SUBJECT: Southern California Edison Company's Response to Notice of Violation

- SCE ATJ 20220405-01, SCE ATJ 20220406-01, SCE ATJ 20220411-

01, and SCE ATJ 20220420-01¹ (No Written Hearing Requested)

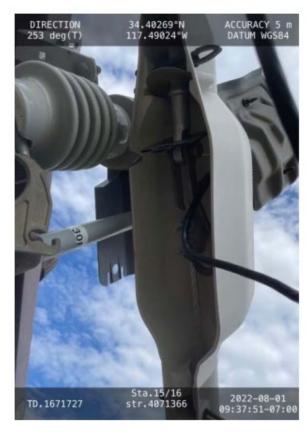
Finding: Missing Fuse Cover

Notice	Finding #	Structures
NOV SCE ATJ 20220420-01	1	4346696E

<u>Summary of Finding:</u> "Pole number 4346696E had a fuse cover that fell off and was found approximately 50 feet from the pole. Energy Safety considers this a violation for failure of adhering to protocol and in the Minor risk category."

Response: SCE agrees the condition existed as identified by Energy Safety, which has already been corrected in the field on August 1, 2022. Please see photo below reflecting the corrected condition.
